GOVERNMENT OF THE DISTRICT OF COLUMBIA
DEPARTMENT OF TRANSPORTATION

MEMORANDUM

SUBJECT: BZA Case No. 18977 – 3220 Prospect Street NW

Figure 1. Proposed Site Plan (Source: Applicant)

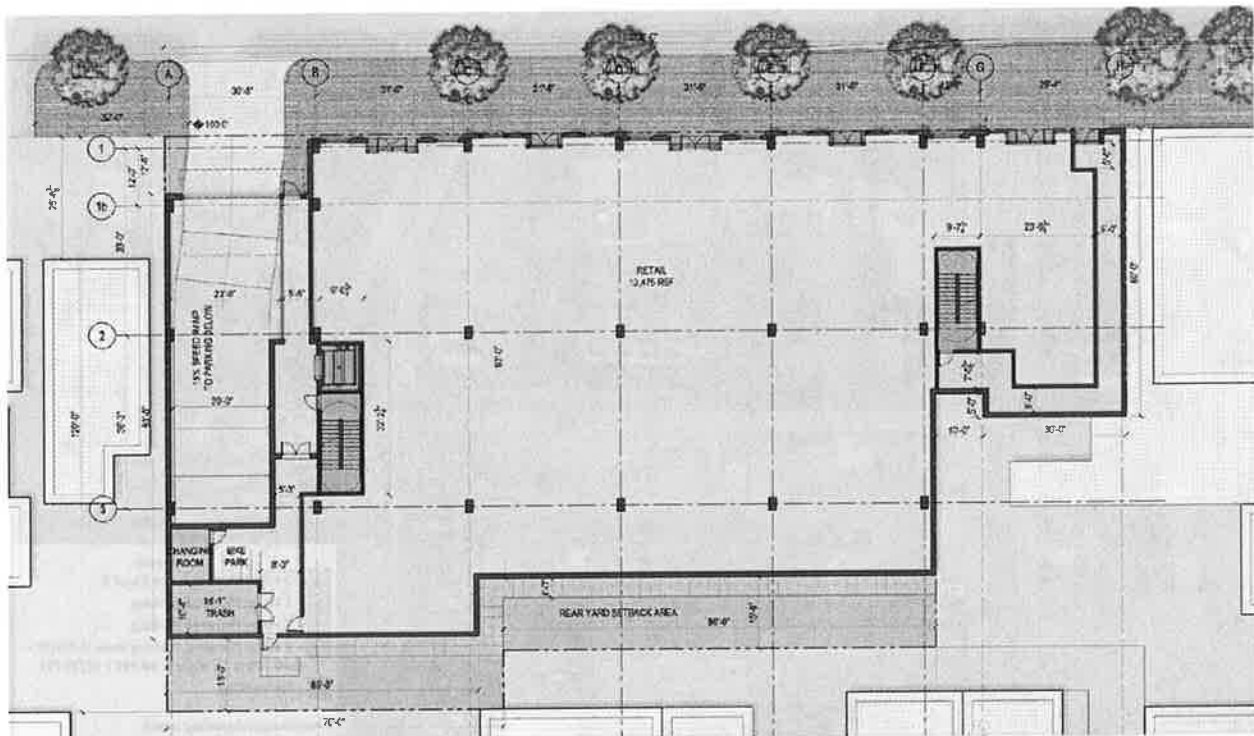
Accordingly, an Applicant is expected to show the existing conditions for each transportation mode affected, the proposed impact on the respective network and any proposed mitigations, along with the effects of the mitigations on other travel modes. A Comprehensive Transportation Review (CTR) should be performed according to DDOT direction. The Applicant and DDOT coordinated on an agreed-upon scope for transportation documentation that is consistent with the scale of this action. An outline of this project's impacts follows below. The proposed Site plan is shown in *Figure 1*.
